The high-frequency pole of the reference CTLE in Annex 120E (comment #r03-12, #r03-45, #r02-21)

Yasuo Hidaka
Fujitsu Laboratories of America, Inc.

IEEE P802.3bs 200GbE and 400GbE Task Force
September 11, 2017 IEEE 802.3 Interim Meeting

Figure 120E-9—Reference continuous time linear equalizer (CTLE) characteristic

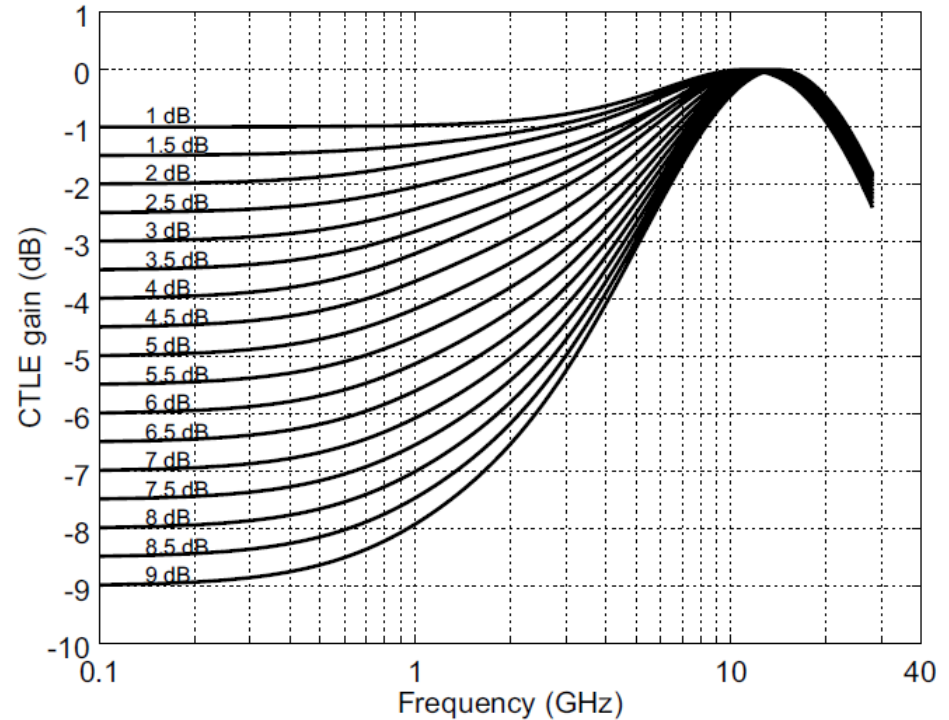
The CTLE in the reference receiver of 120E.3.1.7 does not provide sufficient bandwidth for PAM4 signals as reported recently in P802.3bs Electrical Ad Hoc conference call on June 28, 2017. The effective bandwidth of CTLE is restricted by the lowest pole which is not associated with any zero, because the effects of poles associated with zeroes may be cancelled by the associated zeroes.

In 120E.3.1.7, the pole of the CTLE effective bandwidth is specified as P1. In D3.3, P1 / 2pi is 15.6GHz (0.5873 fb) or 18.6GHz (0.7 fb) that is too low for PAM4. These values remained unchanged since 83E.3.1.6.1 which were chosen for NRZ. They are OK for NRZ, but not OK for PAM4. PAM4 requires higher effective bandwidth of CTLE than NRZ in order to amplify the third harmonics of the signal component. Otherwise, the top and bottom eyes degrade significantly due to the lack of third harmonics.

In COM, the pole of the CTLE effective bandwidth is specified as f_p2. In 120D (chip-to-chip), f_p2 is specified as 53.125GHz (2 fb), which was doubled since 83D.4. 2 fb is sufficiently high to cover the third harmonics which is 1.5 fb.

The requirement of the bandwidth of CTLE is even higher for C2M than C2C, because the device for C2M may not have a DFE. For C2C, DFE can relax the requirement for CTLE bandwidth. Besides, C2M and C2C will be implemented in the same generation of technology. Therefore, we should align the effective bandwidth of reference CTLE between C2M and C2C.

Change P1 / 2pi in Table 120E-2 to 53.125GHz.

Adjust other columns to achieve the max gain of 0dB with the same DC gain.

Update Figure 120E-9 accordingly.

Figure 120E-9 plotted up to $2f_b$

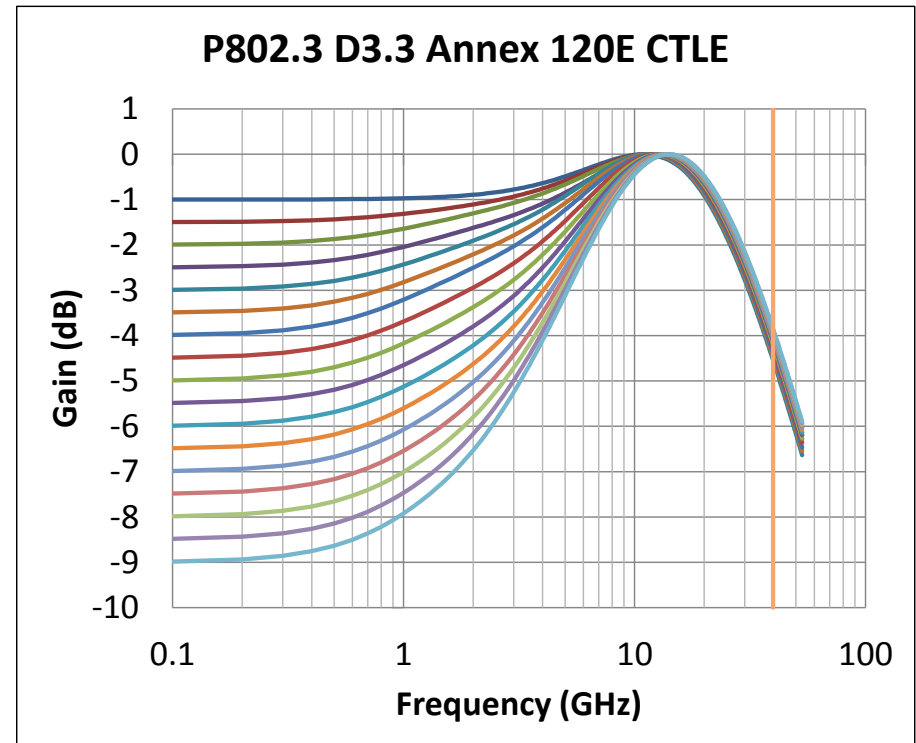
■ Gain at $1.5 \times f_b = 39.8GHz$ is $-4.3dB \sim -3.9dB$

Option 3 (Updated)

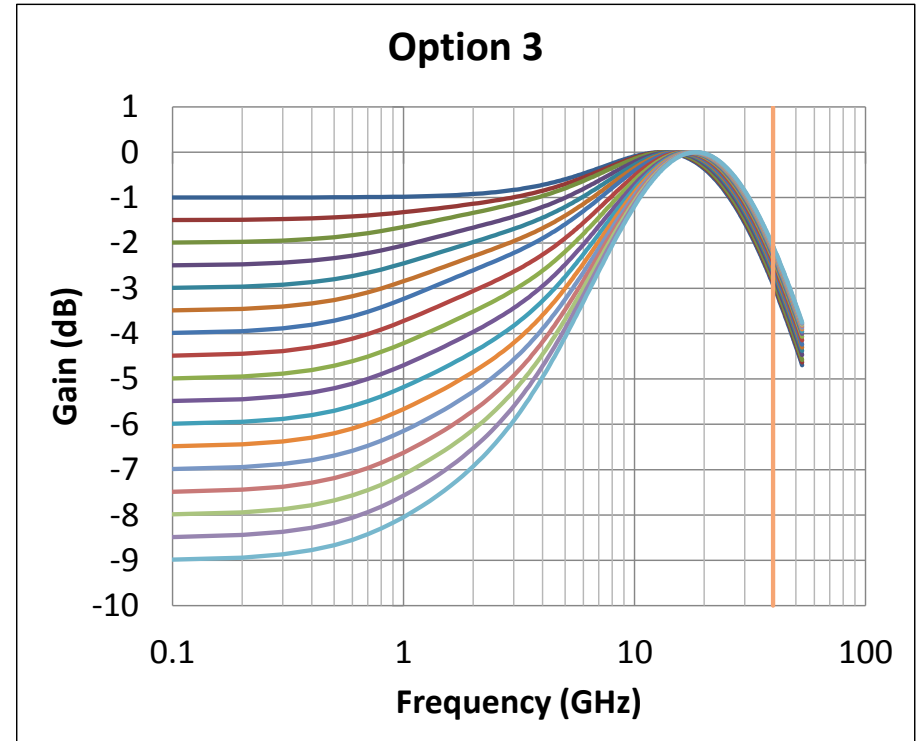
- Increase $P_1/2\pi$ to $1 * f_b$ (align to f_{p2} of CEI-56G-MR-PAM4)
- Gain at $1.5 \times f_b = 39.8GHz$ is $-2.9dB \sim -2.1dB$

■ For 120E, I recommend to take option 3

- Increase $P_1/2\pi$ to $1 * f_b$ ($= f_{p2}$ of CEI-56G-MR-PAM4)

Figure 120E-12—Example module stressed input test

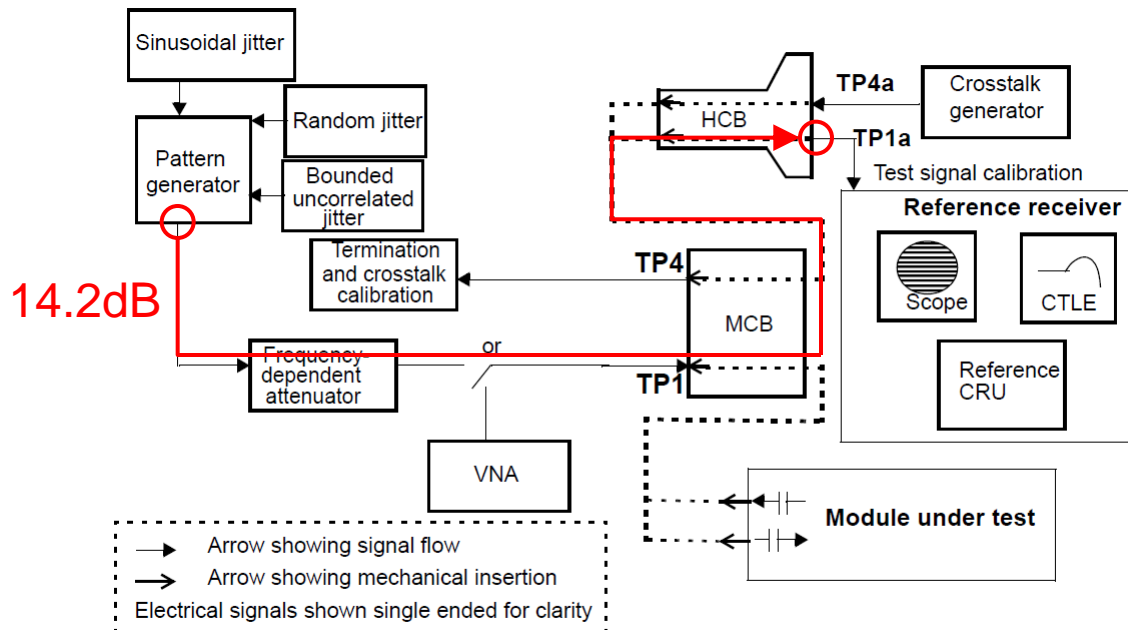
The module output is measured with a 10.5 dB channel (part mated compliance boards, part software channel) plus module's own loss with EW, EH 0.2, 30. The module stressed input signal is measured after a 14.2 dB hardware channel, plus pattern generator's own loss, with EW, EH 0.22, 32 - not very different. Although the host and pattern generator are expected to have more sophisticated outputs than the module, it is said that the stressed signal EW is not feasible - this may be because of the extra loss.

Reduce the 14.2 dB loss because some of the loss is already in the pattern generator and the 14.2 dB represents all the loss including a long host IC package path. We could choose to let the max trace loss, max package loss host look after itself to an extent and target something between 10.5 (no package) and 14.2 (max package). Equivalently, don't connect the longest package trace to the longest PCB trace! Some other metric such as (unequalized) pulse height that takes the pattern generator into account may be better than test channel loss.
